Executive Director's Recommendation

Commission Meeting: July 9, 2020

PROJECT Freer Gallery of Art Courtyard Accessibility Improvements 1050 Independence Avenue, SW Washington, DC	NCPC FILE NUMBER 8182
	NCPC MAP FILE NUMBER 1.41(38.00)45147
SUBMITTED BY Smithsonian Institution	APPLICANT'S REQUEST Approval of comments on concept plans
REVIEW AUTHORITY Federal Projects in the District per 40 U.S.C. § 8722(b)(1) and (d)	PROPOSED ACTION Approve comments on concept plans
	ACTION ITEM TYPE Consent Calendar

Comments on Concept Plans

Proposed Courtyard Plan

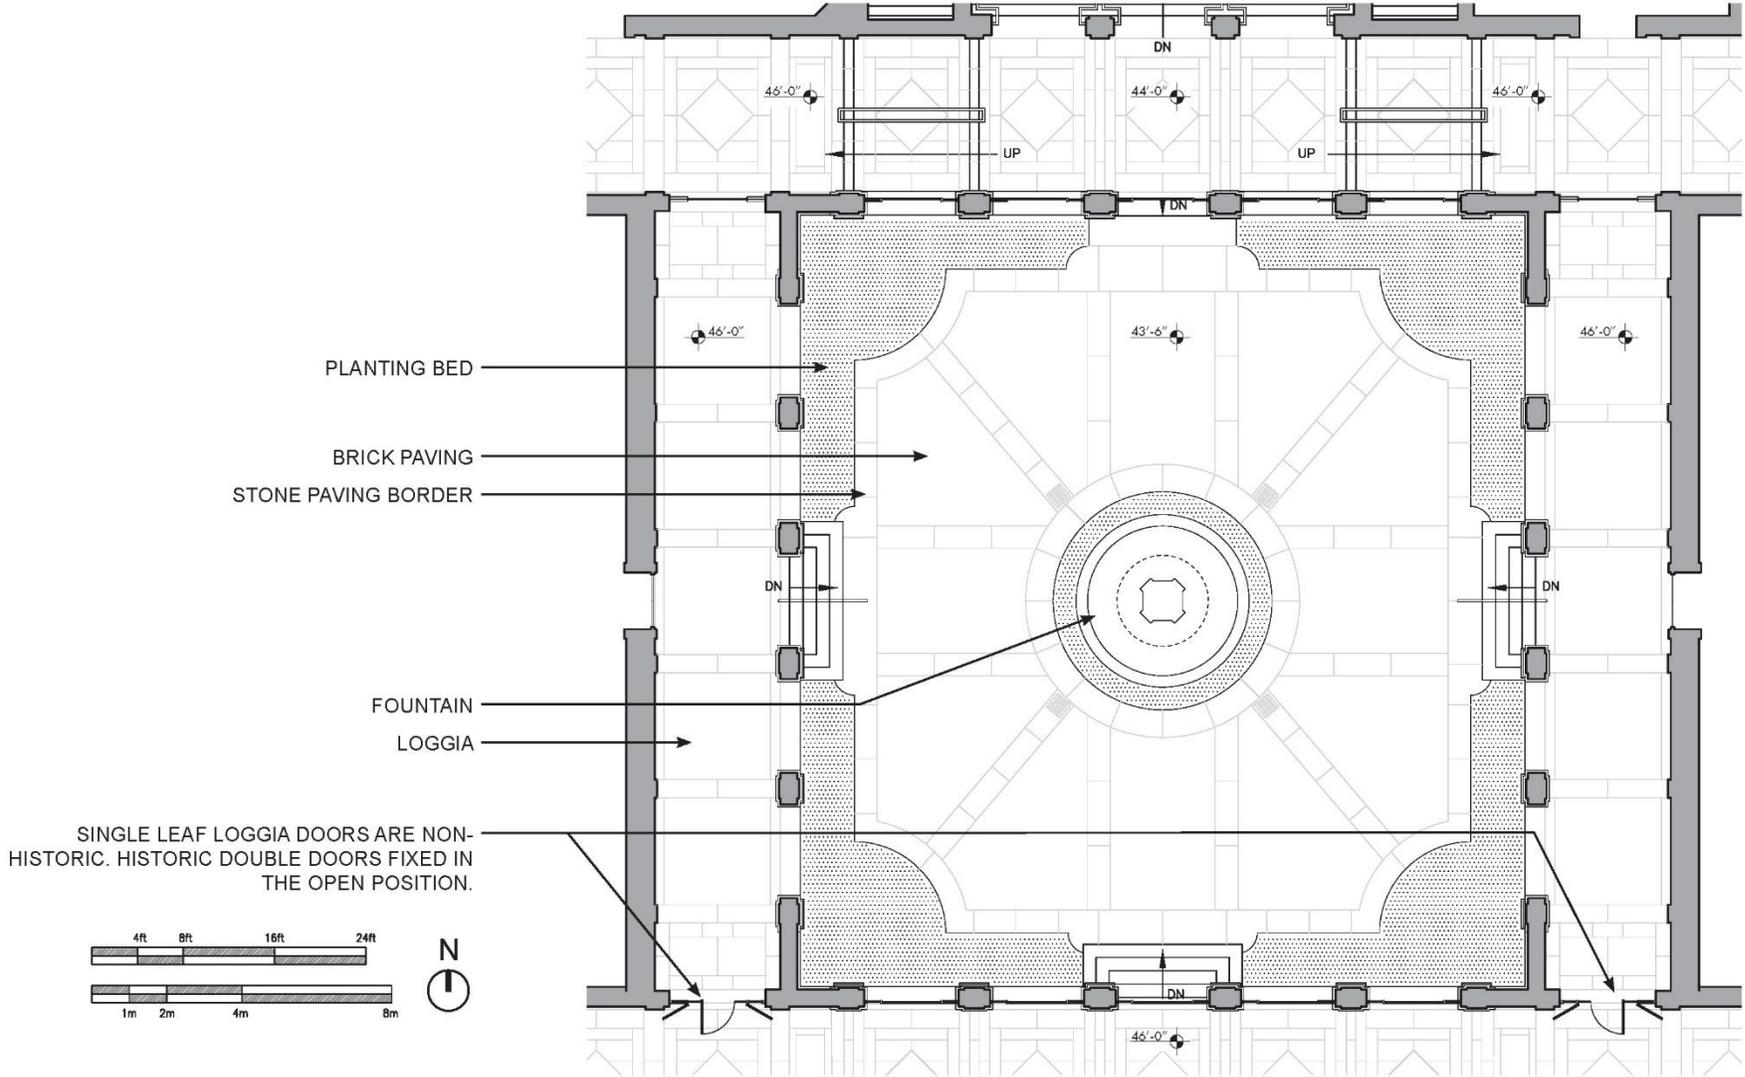
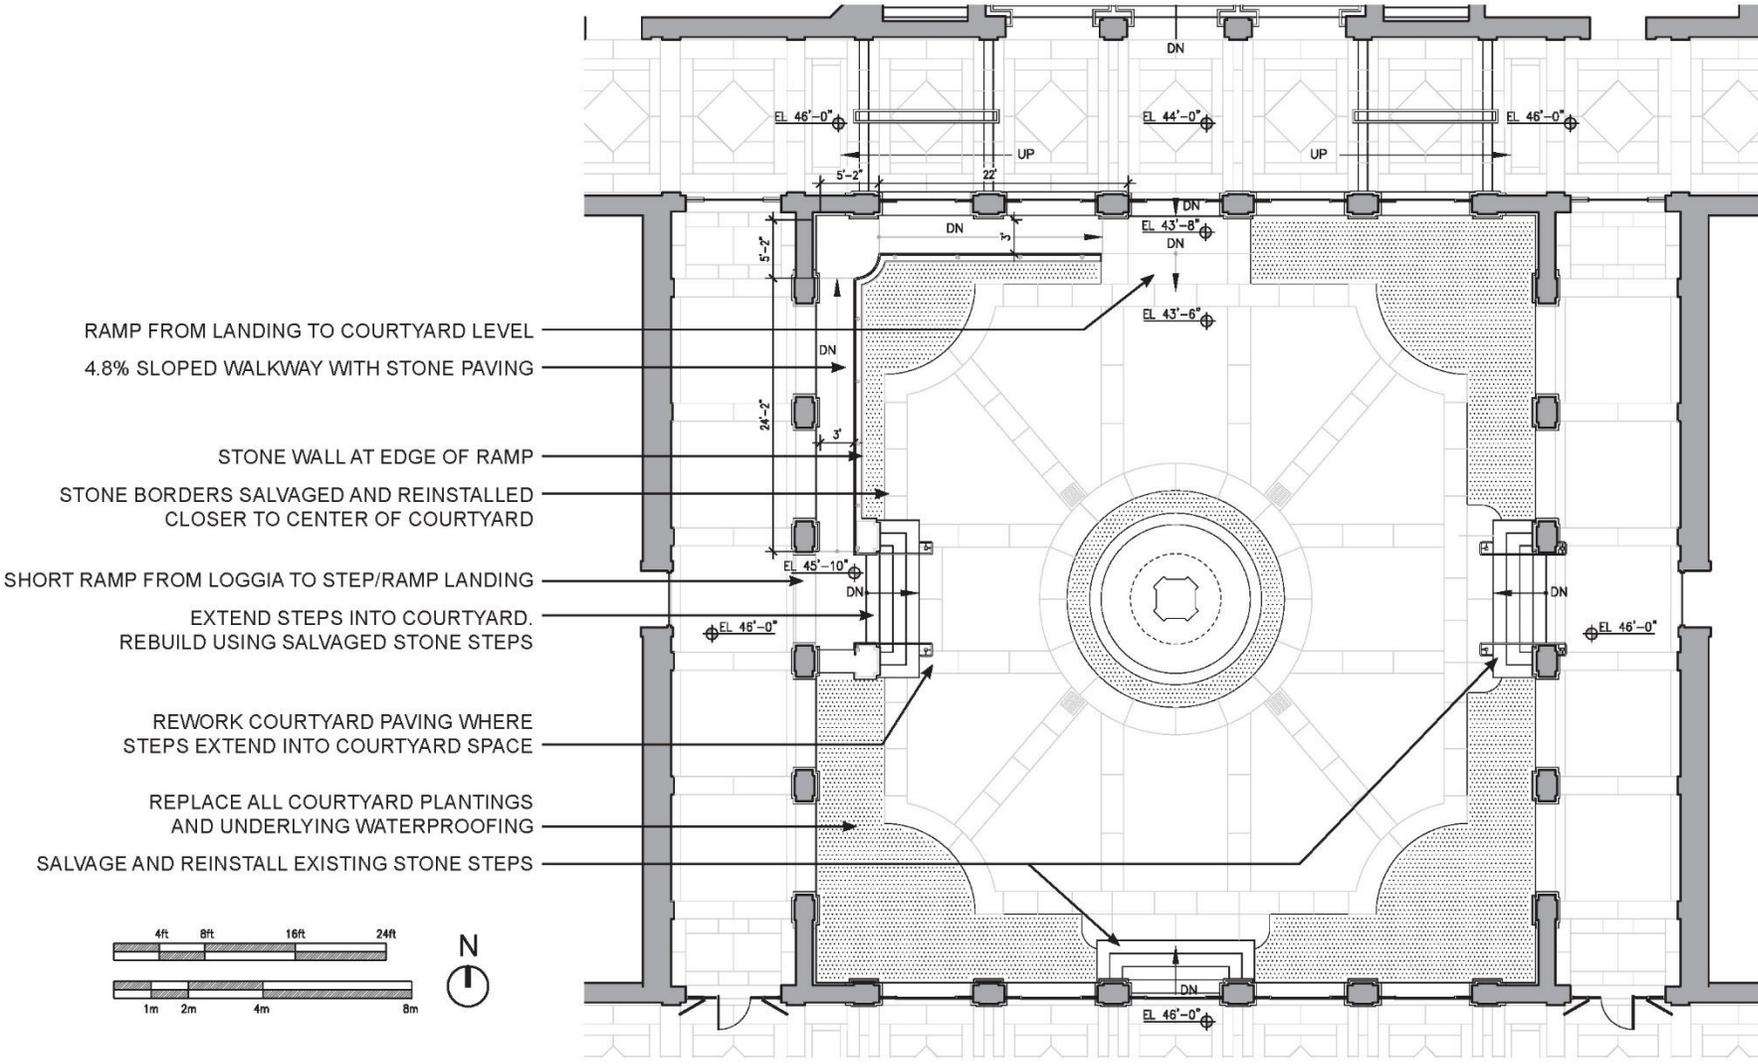
Finds the overall design approach is appropriate for the project purpose and historic courtyard setting, and that details of the ramp design and hardscape will be further refined prior to the next review.

The proposed project includes a new ramp from the west loggia to the north end of the courtyard with a sloped walkway with detailing reflecting the historic building. This side was selected due

to its proximity to the Main Floor's accessible entrance, and because the area north of the landing allows more space for the walkway. The proposed slope is less than five percent. A planter width is provided adjacent to the new walkway and the planted areas in the other three quadrants of the courtyard are proposed to be slightly widened to maintain alignments with pavement edges. Integration of the proposed walkway into the planted area maintains the overall symmetry of the space. The new paving and ramp materials reflect the original courtyard materials, including Tennessee Pink marble for the wall panels, cap stones and plinths, along with Milford Pink granite for the paving at the new walkway. Existing stonework will be salvaged and reinstalled where possible. New handrails will be dark bronze to match the vocabulary of the building's original architectural metalwork.

Overall, the walkway has been designed to be minimally intrusive to the historic character of the courtyard with elements such as the handrails located to have nominal impact to historic fabric around the courtyard. As such, staff recommends the **Commission find the overall design approach is appropriate for the project purpose and historic courtyard setting, and that details of the ramp design and hardscape will be further refined prior to the next review.**

The Commission members expressed general support for the proposed placement of a sloped walkway along two sides of the courtyard to provide barrier-free access to the courtyard level from the museum's adjacent corridors and for adjustments to the courtyard landscape, endorsing the conceptual approach of honoring the character of the original Renaissance Revival design by Charles Platt. They supported the proposal for the sloped walkway as derived from the existing architecture while minimizing change to the courtyard; they suggested that the generic character of the bronze handrails along the sloped walkway could be customized in a subtle way to refer to the museum's mission and collections.
